Project Name: Delray Plaza (fka Lavers International Plaza)
Project Location: 600 West Linton Boulevard
Request: Class IV Site Plan Modification
Board: Site Plan Review and Appearance Board
Meeting Date: May 10, 2017

---STAFF REPORT---

ITEM: **Delray Plaza (2017-115)** – Class IV Site Plan Modification, Landscape Plan, Architectural Elevation, and Waiver associated with the demolition of existing Buildings, construction of three new buildings, and exterior alterations to existing buildings with associated site improvements.

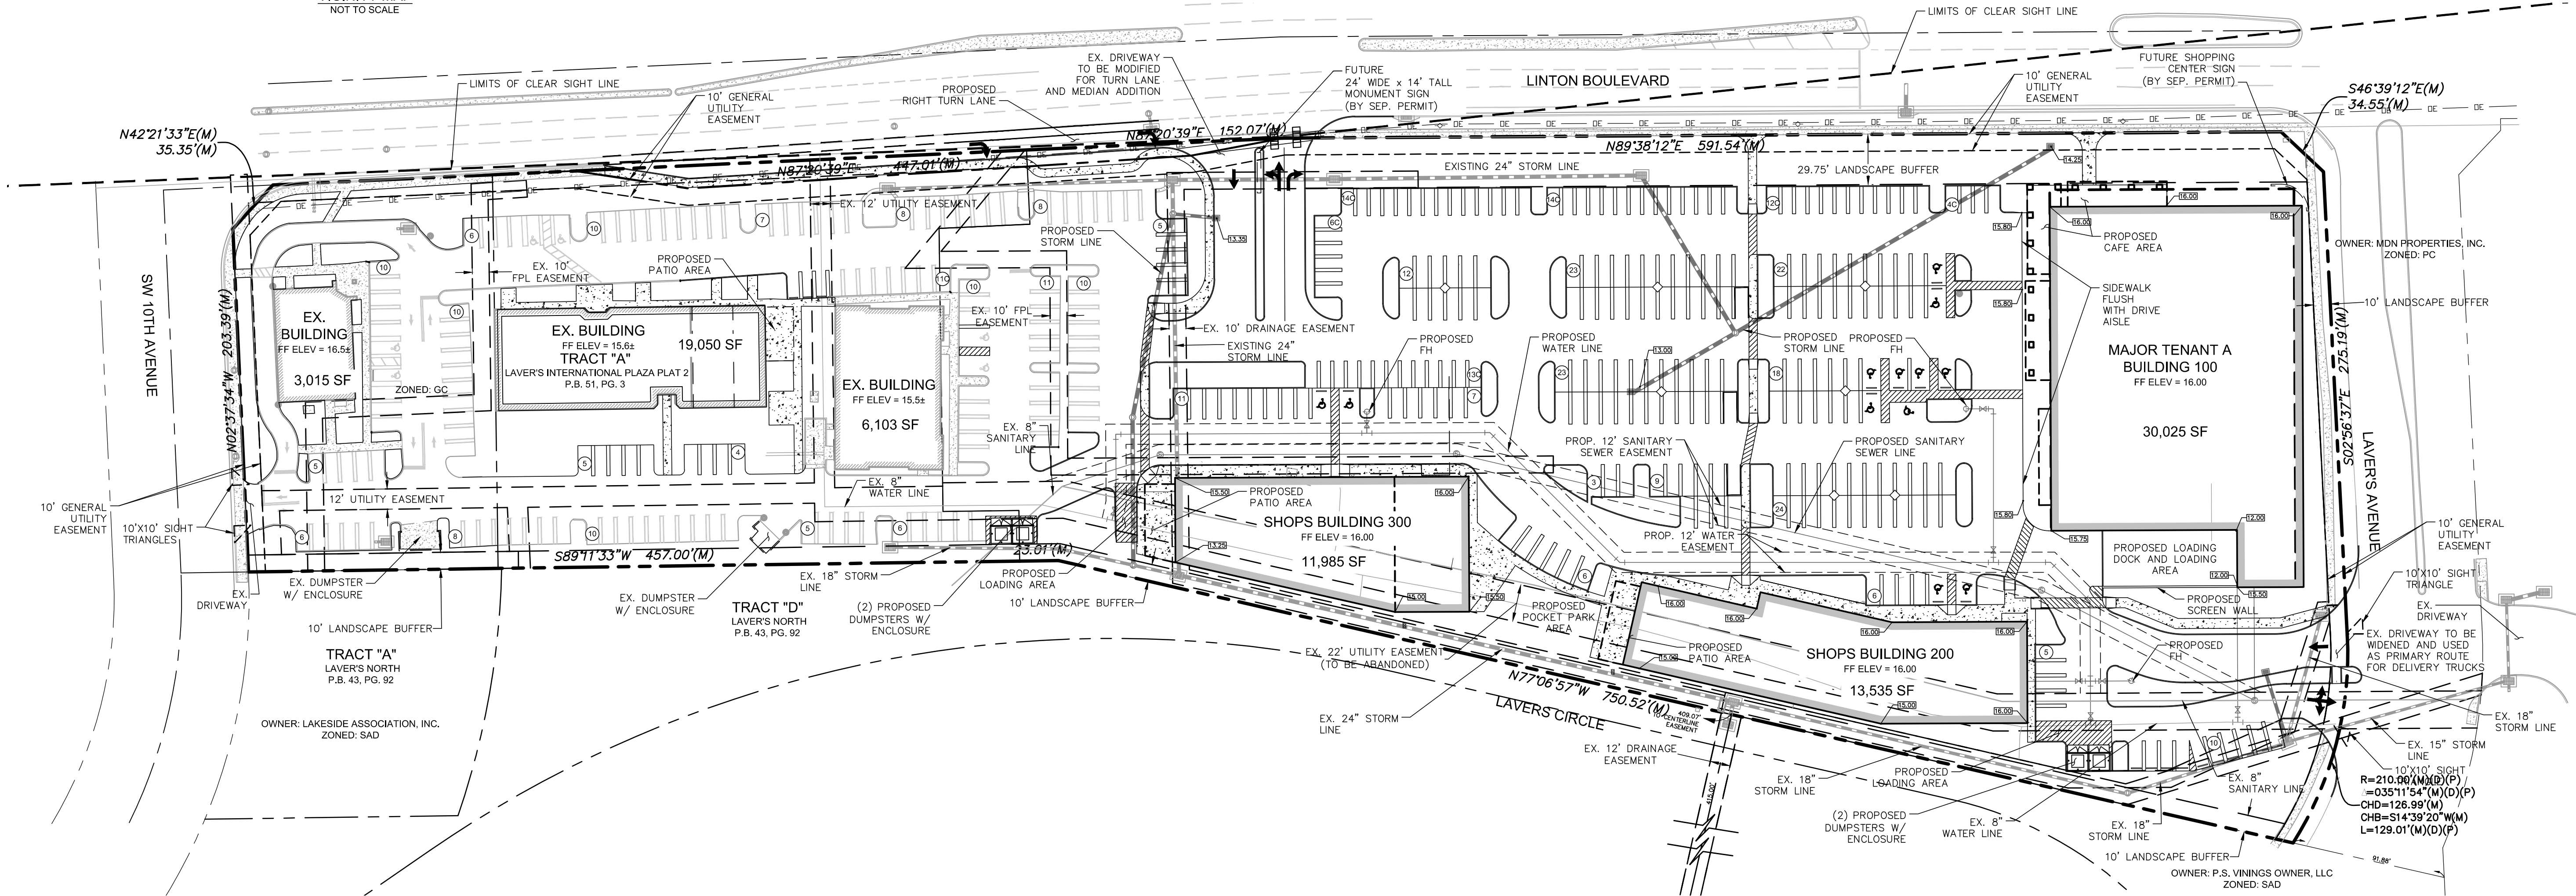
1. That Civil Sheet C-400 be revised prior to site plan certification, which includes the Pollo Tropical parcel in the "Total Floor Area" Project Data Table. Total proposed area is 80,698 square feet, as opposed to the noted 83,713 square feet.
